# Middlesex House

Design Update Document

1759-FPA-XX-RP-A-16002-01

# Ground floor Approved

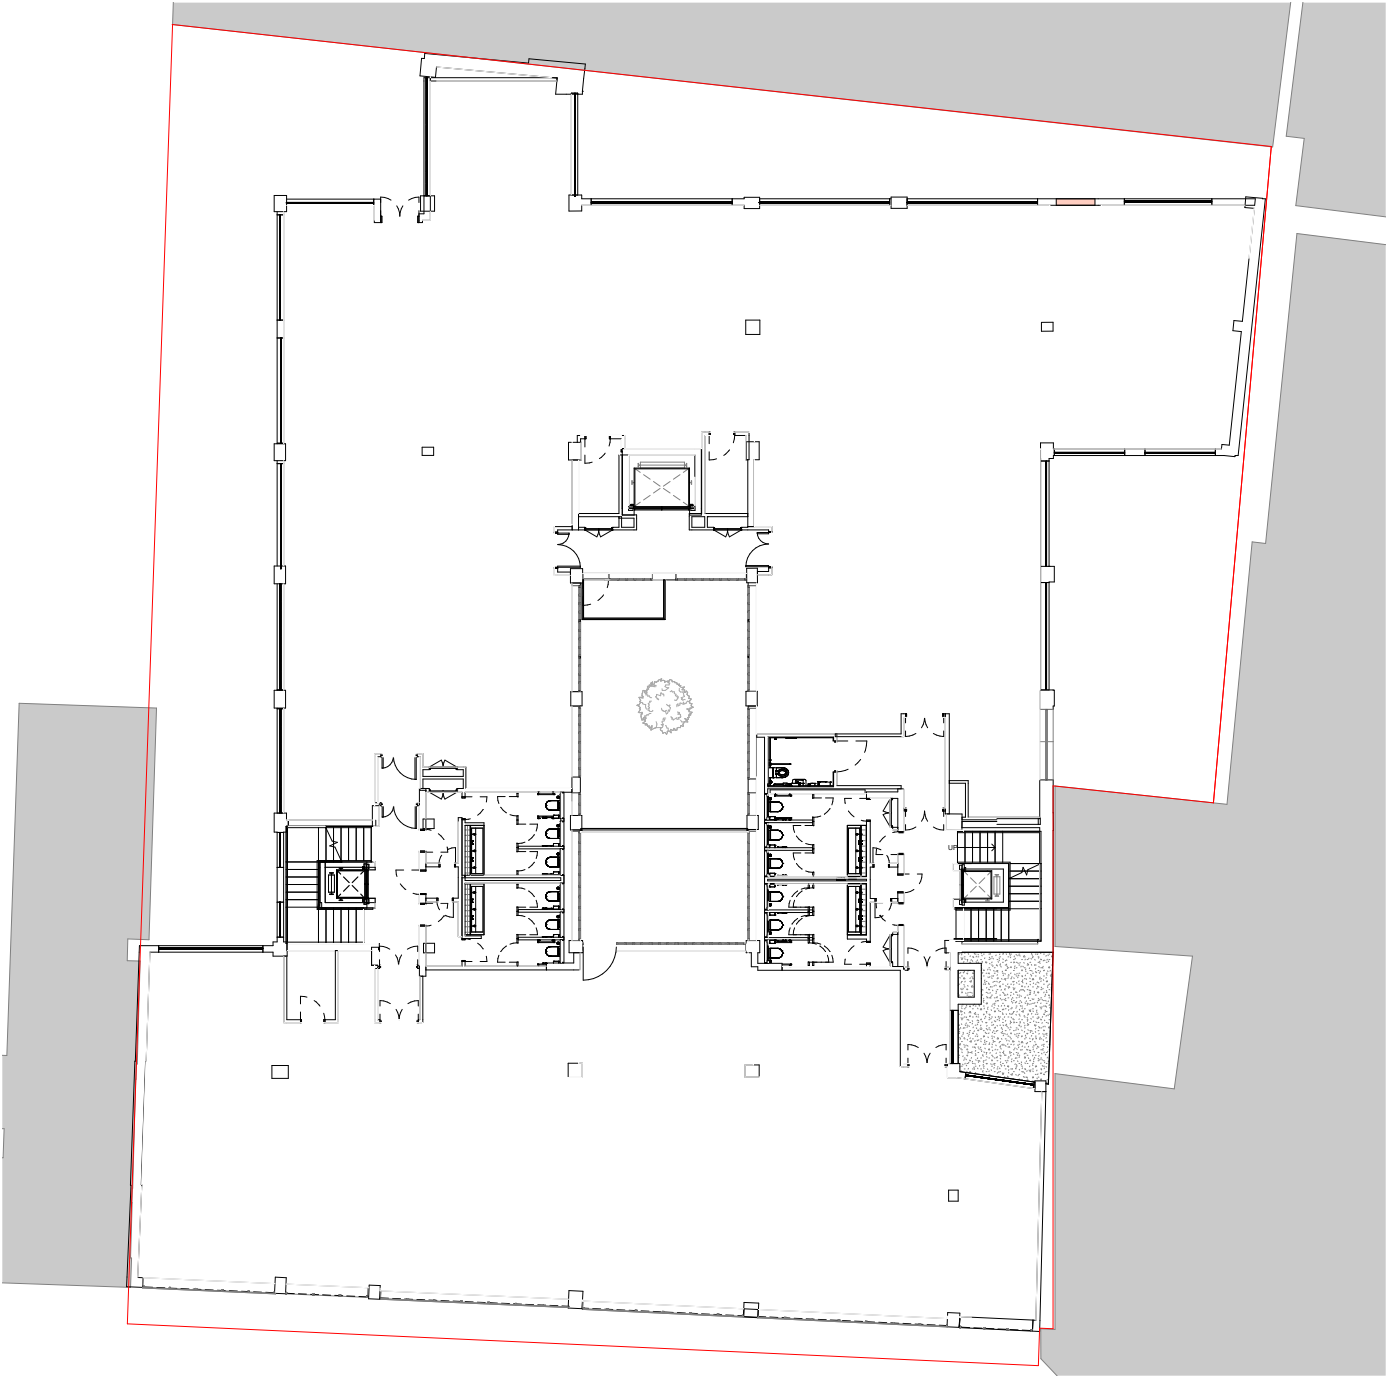
The proposed amendments include a simplification of the main entrance door and addition of a canopy over it; some minor updates to the south core and adjacent ventilation shafts on the office floors; and updates to the roof terrace design, including an increase in the height of the plant screen, and an additional WC.

On the ground floor, the new entrance design and additional ramp improve accessibility and use of the building. The new door design retains the symmetry of the consented, but offers more flexibility in its use, and is easier to operate.

# First floor Approved

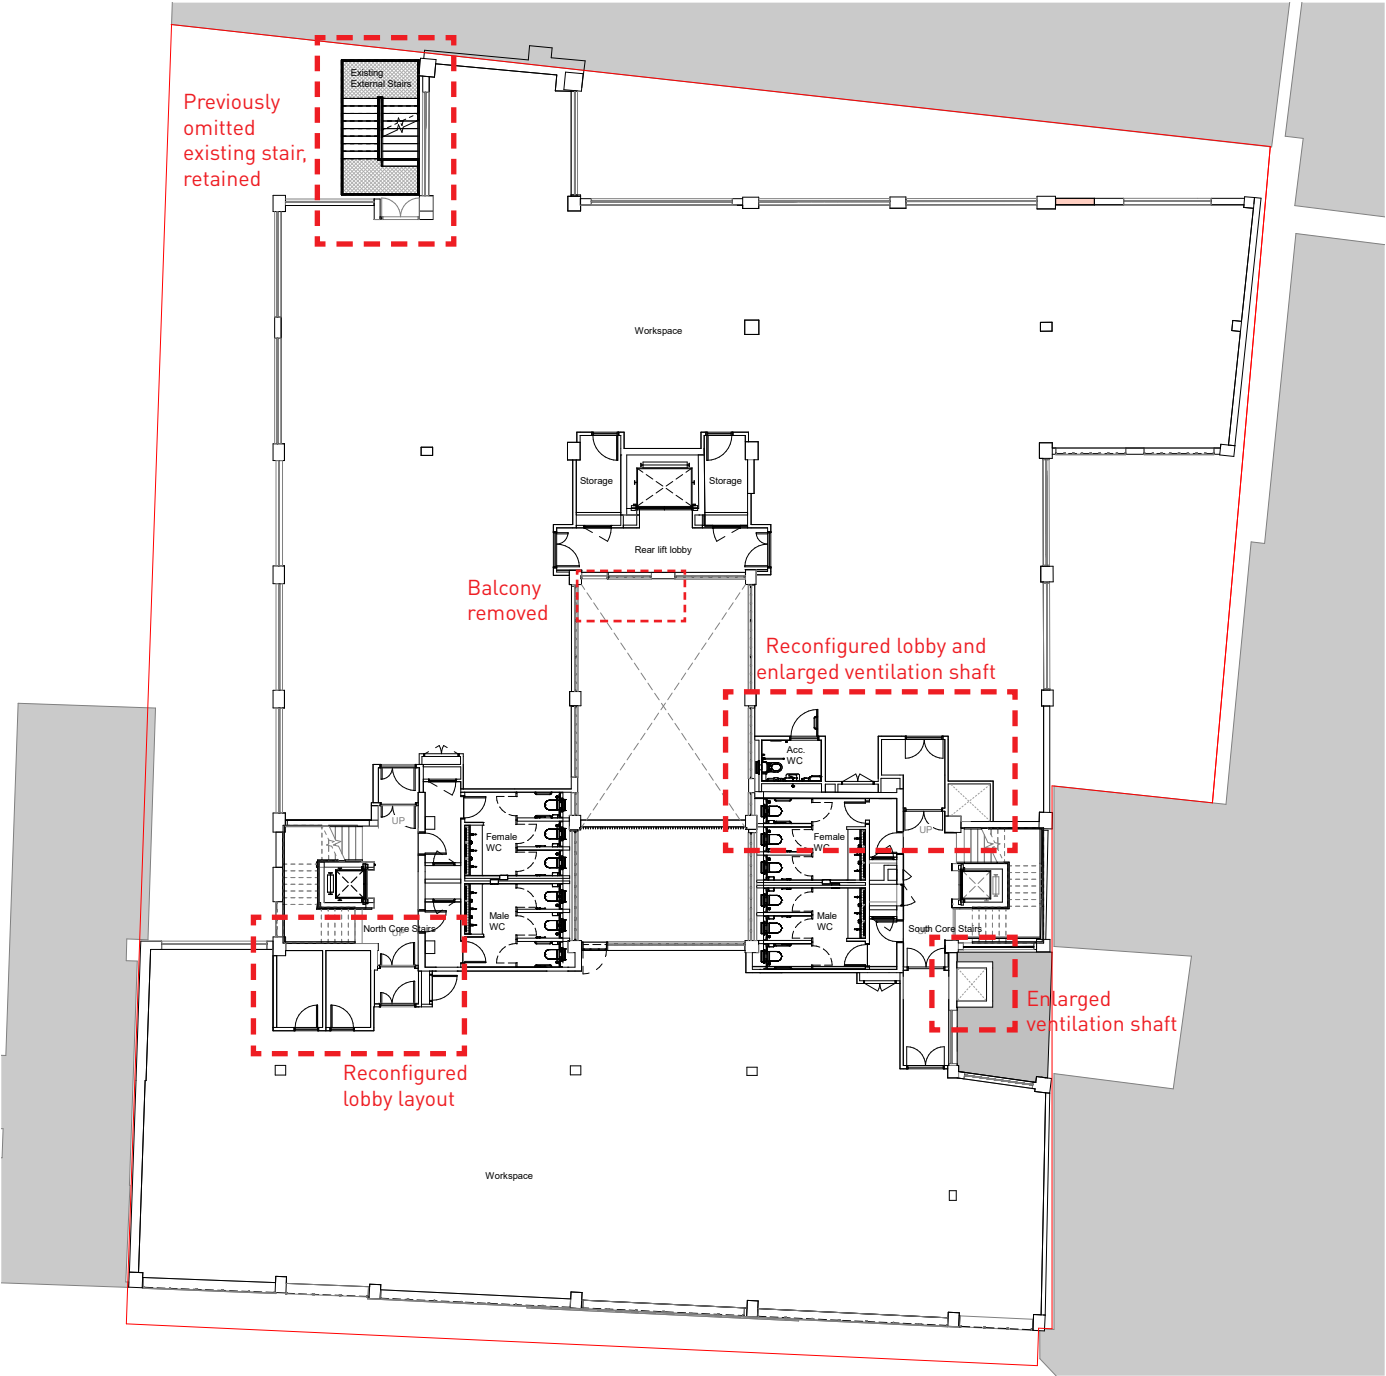
On the office floors, the removal of the consented balconies helps to retain the existing levels of daylight in the courtyard. Internally, the ventilation shafts and lobbies are updated to the latest detailed advice from the Fire and MEPH engineers. On the second floor, the consented location of the WCs is brought back to the existing, simplifying the renovation process.

# Roof floor Approved

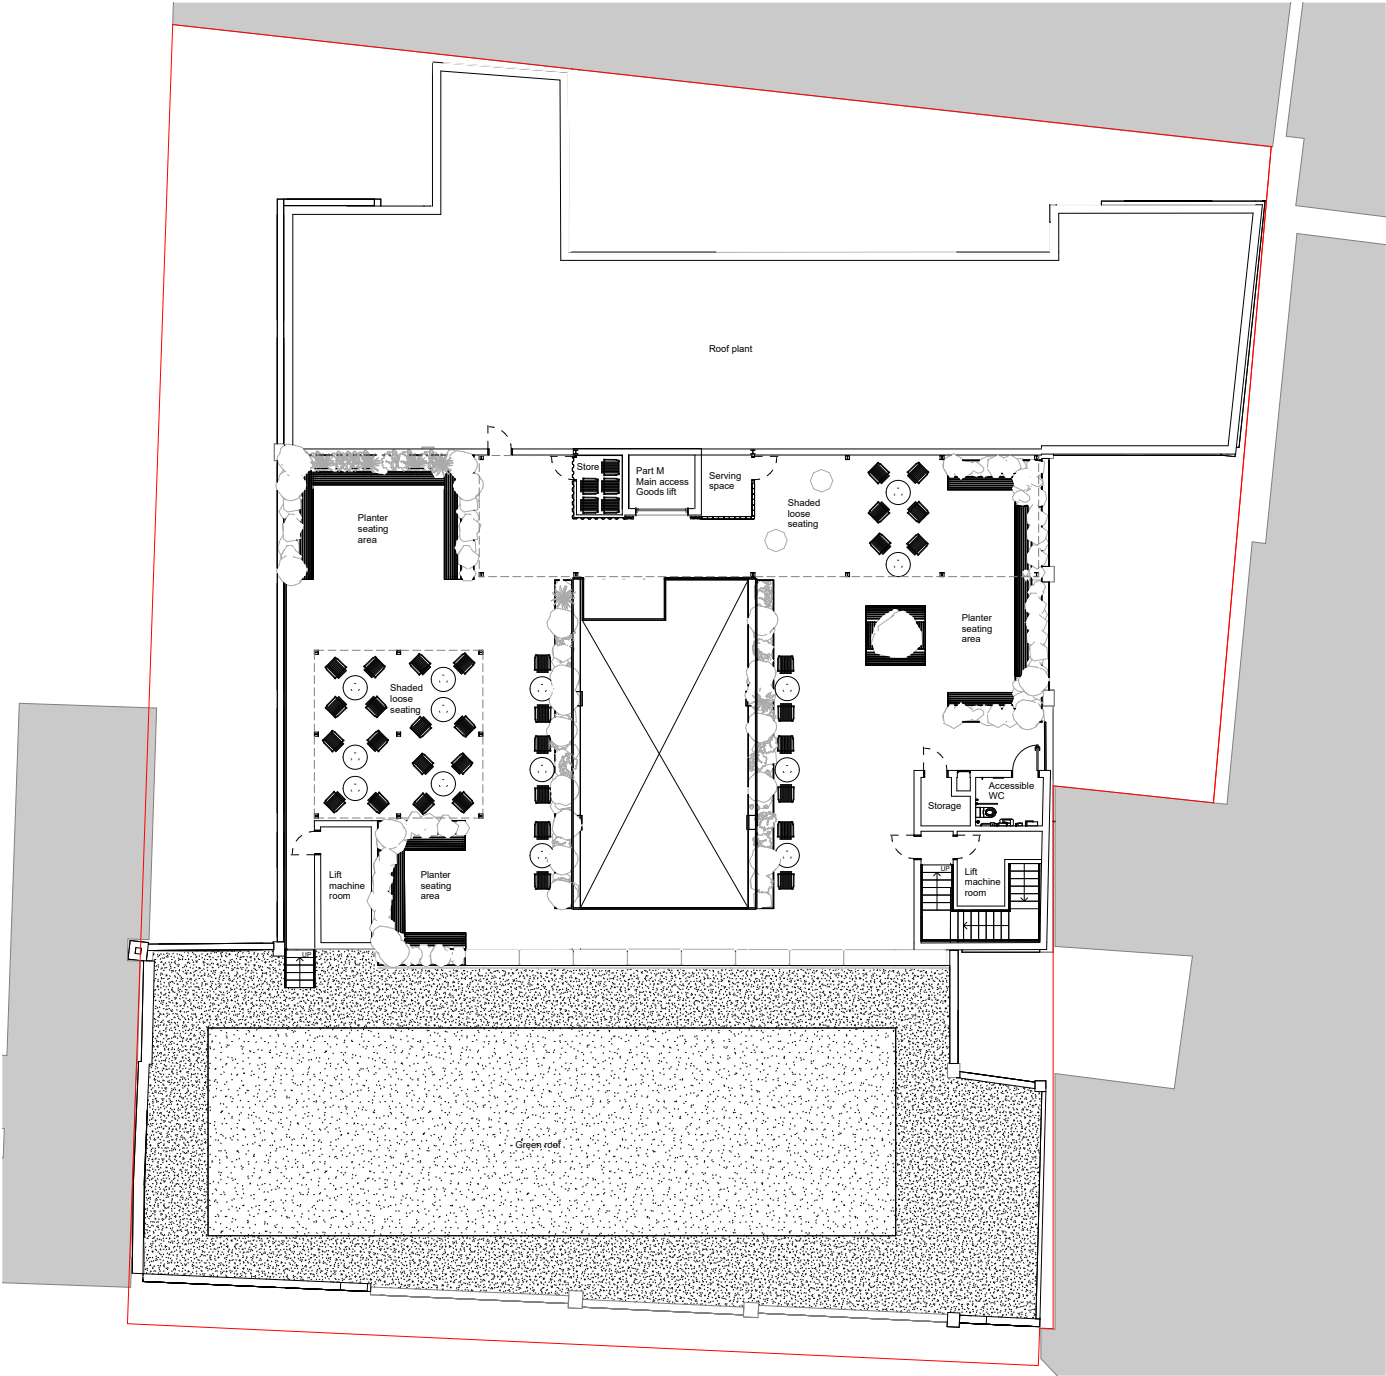
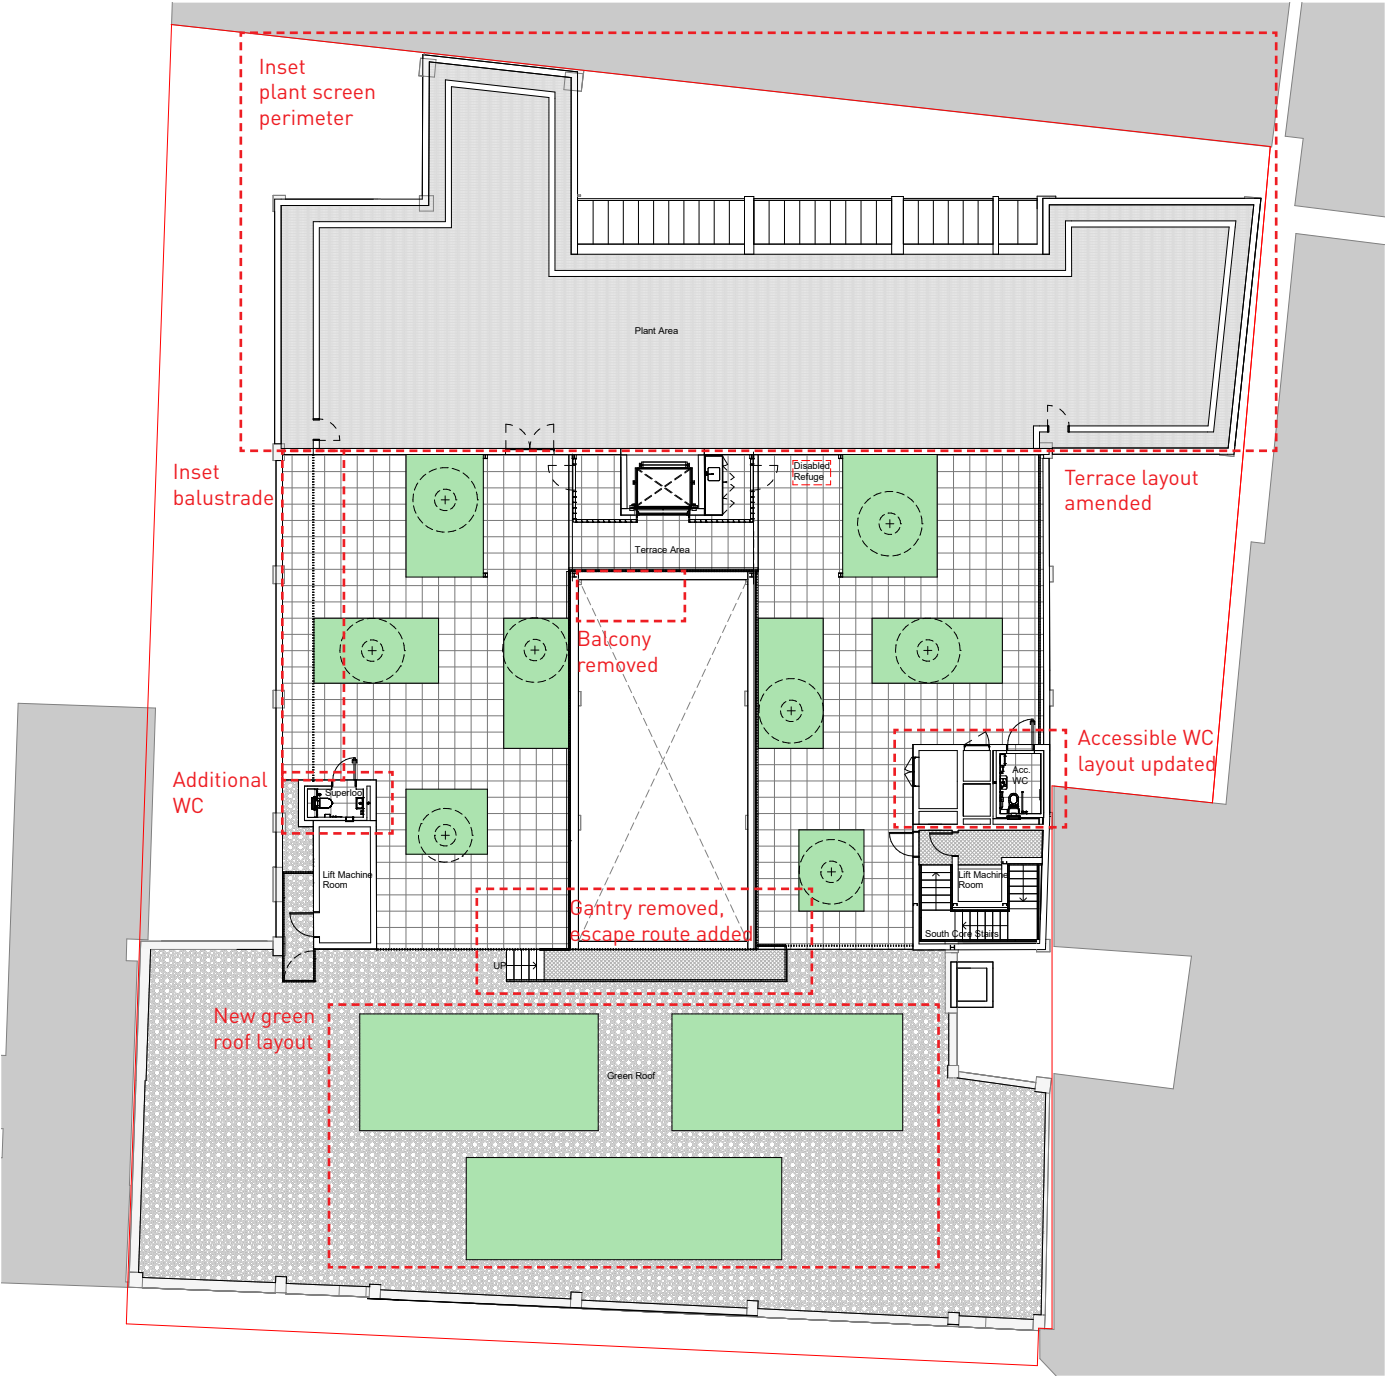
On the roof, the plant screen height is proposed to increase, which would ensure all equipment is out of sight. The terrace is proposed to have a more fluid landscape design, with fewer canopies and instead the addition of a number of trees, making it a more enjoyable view for the surrounding context. An additional superloo is proposed as well, to guarantee access to the accessible WC by those who need it.
